To: Liz Aguiar, Principal Planner

Date: June 24, 2024

RE: Mainstreet at Coconut Creek Site Plan – Block 3

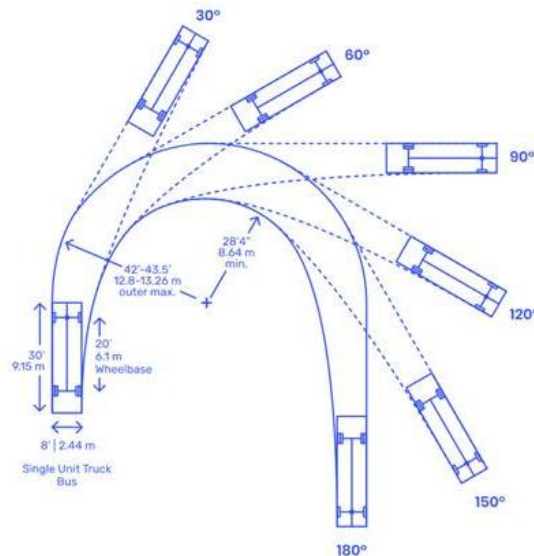
The turning path of a City Fire Truck measures the minimum possible turning radius necessary for performing a *U-turn* in a vehicle with a 20' (6.1 m) wheelbase.

Measuring the inner and outer radii of the 180° turn, a minimum inner radius of 28'4" (8.64 m) and minimum outer radius between 42'-43.5' (12.8-13.26 m) should be provided for City Fire Trucks;

RESPONSE: The plan does not provide dead ends so U-turns should not be required for access.

RESPONSE: Refer to the Fire Access Plan which depicts the movement of City fire trucks throughout the site.
